**Recommendations to the SCSI-3 working group for consideration into
SCSI-3 Parallel Interface (SPI)**

Prepared by Rick Muething
Emulex Corporation; Nov 13, 1991

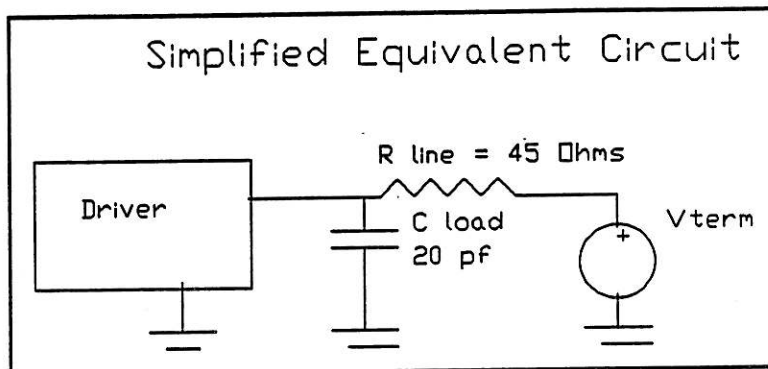
Although edge rate specs are usually described in terms of volts/nanosecond (which can be easily observed and measured) equally important is the current edge rate limit, di/dt max. Excessive di/dt operating through bonding, package and PC inductance causes ground and Vdd bounce which further degrade system noise margin. Measuring edge current rates can be difficult since introducing the measurement probe can easily modify the circuit inductance and corrupt the measurement. SPICE simulations allow one way of predicting edge currents when the driver environment is modeled correctly to include parasitic inductance and capacitance. There are a number of well known implementation techniques to control driver turn on turn off characteristics.

Since the SCSI driver looks into a transmission line, a simplified resistive equivalent can be used as "test circuit" for measuring or simulating edge currents and voltages. An appropriate model would

be a resistor value equal to half the nominal cable impedance (not necessarily half the value of the termination resistor!) to a voltage source equal to the quiescent termination voltage. A parasitic capacitance of say 20pf can be added to Gnd to accommodate practical considerations such as connectors or scope probe capacitance. This works up to the equivalent circuit shown in Fig 1.

Of course the other parasitic parts of the driver circuit (lead and package inductance, via and bond wire resistance, distributed drain and pad capacitance etc) will have to be included for accurate SPICE modeling. Based a circuit similar to the above the driver should be specified for the following parameters:

Min	Max
Driver assertion:	Voltage edge rate; $-.25\text{V/ns}$	$-.5\text{V/ns}$
	Current di/dt: (+ in to driver)	15ma/ns
Driver Negation:	Voltage edge rate: $+.25\text{V/ns}$	$+.5\text{V/ns}$
(Including active negation)	Current di/dt	-15ma/ns

Note: The above numbers are preliminary and should be confirmed by analysis and simulation of drivers using the above test circuit.
